**Economic and Social Council**Distr.: General
12 March 2019

Economic Commission for Europe**Inland Transport Committee****World Forum for Harmonization of Vehicle Regulations****Working Party on Pollution and Energy****Seventieth session**

Any other business**Proposal for amendments to the Consolidated Resolution on
the Construction of Vehicles (R.E.3)****Submitted by the experts from the Association for Emissions Control
by Catalyst, the European Association of Automotive Suppliers and the
International Organization of Motor Vehicle Manufacturers***

The purpose of this proposal, tabled by the experts from the Association for Emissions Control by Catalyst (AECC), the European Association of Automotive Suppliers (CLEPA) and the International Organization of Motor Vehicle Manufacturers (OICA), is to propose amendments to the recommendation on market fuel quality, contained in the Consolidated Resolution on the Construction of Vehicles (R.E.3).

Figure A4-1: Relation between vapour pressure (VP), E70 and VLI for the ten different volatility classes for unleaded petrol with a maximum oxygen content of 2.7% (m/m).

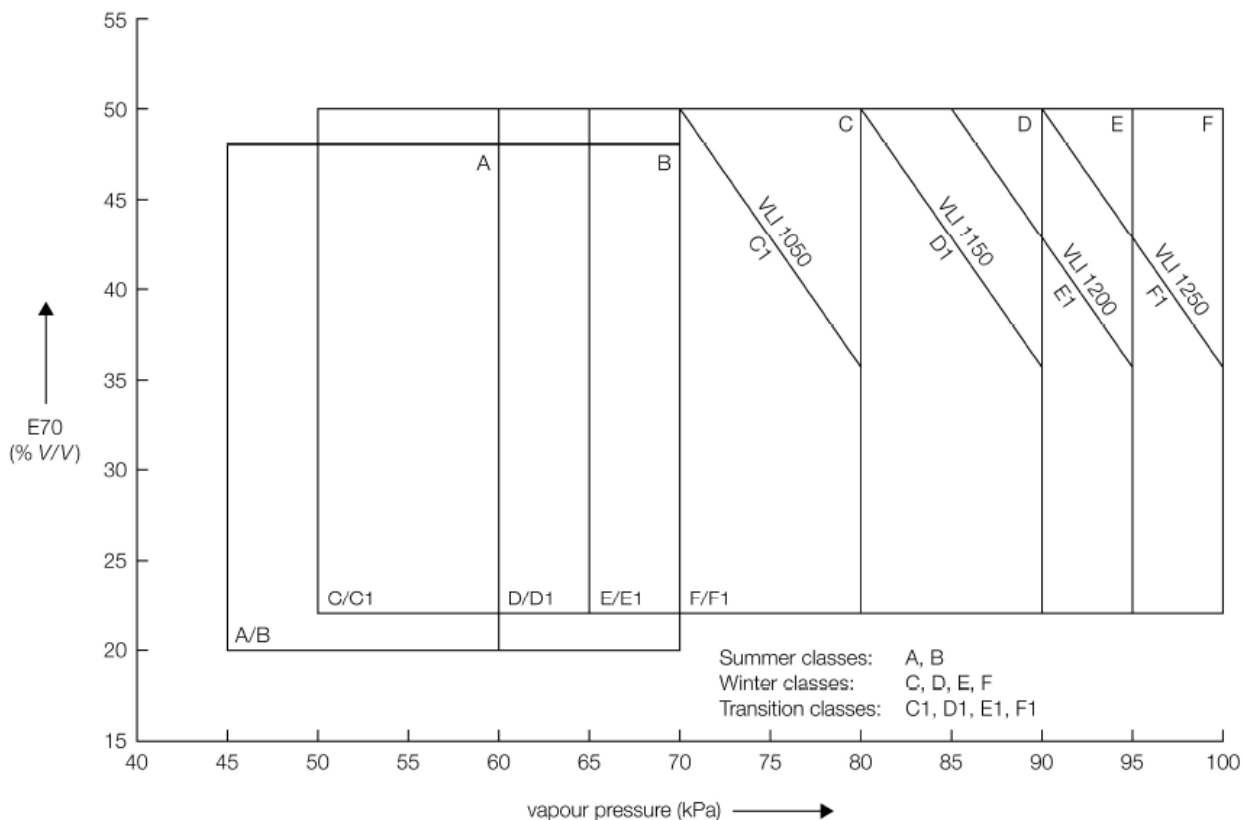
7.2.1. Volatility Classes for Unleaded Gasoline (R83.03, R83.05, R83.06, R83.07 - E5 gasoline blend)

Class ^(*)	A	B	C/C1	D/D1	E/E1	F/F1
Vapour pressure (kPa)	45 - 60	45 - 70	50 - 80	60 - 90	65 - 95	70 - 100
E70 (%) ¹	20 - 48	20 - 48	22 - 50	22 - 50	22 - 50	22 - 50
E100 (%) ¹	46 - 71	46 - 71	46 - 71	46 - 71	46 - 71	46 - 71
E150 (% min) ¹	75	75	75	75	75	75
Final boiling point (°C max) ¹	210	210	210	210	210	210
T10 (°C) ¹	65	60	55	50	45	45
T50 (°C) ¹	77 - 100	77 - 100	75 - 100	70 - 100	65 - 100	65 - 100
T90 (°C) ¹	130 - 175	130 - 175	130 - 175	130 - 175	130 - 175	130 - 175
Distillation residue (% V/V, max)	2	2	2	2	2	2
Vapour Lock Index (VLI) (10 VP + 7 E70) (index max)	-	-	C	D	E	F
Vapour Lock Index (VLI) (10 VP + 7 E70) (index max)			C1 1 050	D1 1 150	E1 1 200	F1 1 250

Figure A4-2: Relation between vapour pressure (VP), E70 and VLI for the ten different volatility classes for unleaded petrol with a maximum oxygen content of 3.7% (m/m).

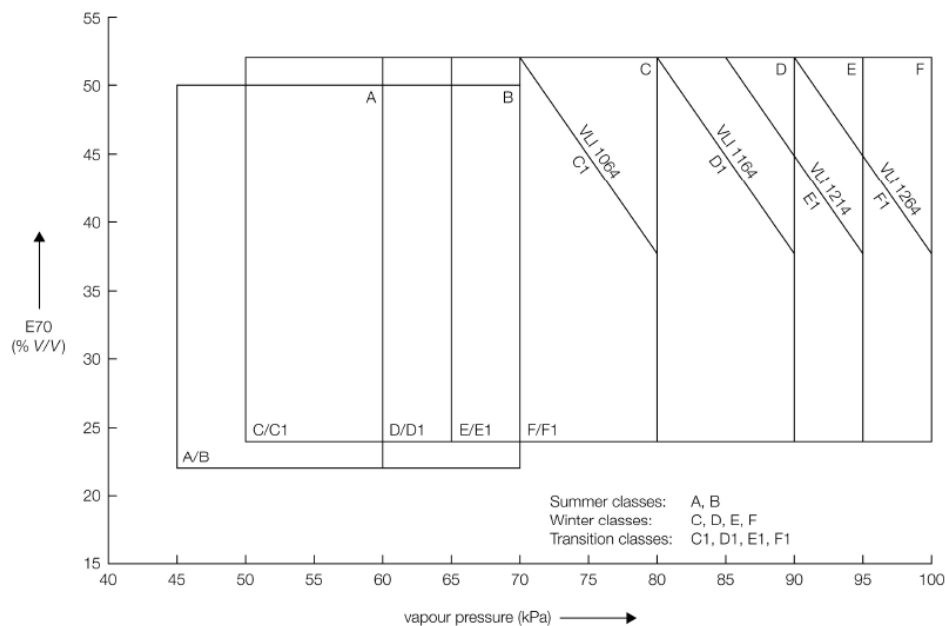
7.2.2. Volatility Classes for Unleaded Gasoline (R83.07 - E10 gasoline blend)

Class (*)	A	B	C/C1	D/D1	E/E1	F/F1
Vapour pressure (kPa)	45 - 60	45 - 70	50 - 80	60 - 90	65 - 95	70 - 100
E70 (%) ¹	22 - 50	22 - 50	24 - 52	24 - 52	24 - 52	24 - 52
E100 (%) ¹	46 - 72	46 - 72	46 - 72	46 - 72	46 - 72	46 - 72
E150 (% min) ¹	75	75	75	75	75	75
Final boiling point (°C max) ¹	210	210	210	210	210	210
T10 (°C) ¹	65	60	55	50	45	45
T50 (°C) ¹	65 - 100	65 - 100	65 - 100	65 - 100	65 - 100	65 - 100
T90 (°C) ¹	130 - 175	130 - 175	130 - 175	130 - 175	130 - 175	130 - 175
Distillation residue (% V/V max)	2	2	2	2	2	2
Vapour Lock Index (VLI) (10 VP + 7 E70) (index max)	-	-	C	D	E	F
Vapour Lock Index (VLI) (10 VP + 7 E70) (index max)			C1 1 064	D1 1 164	E1 1 214	F1 1 264
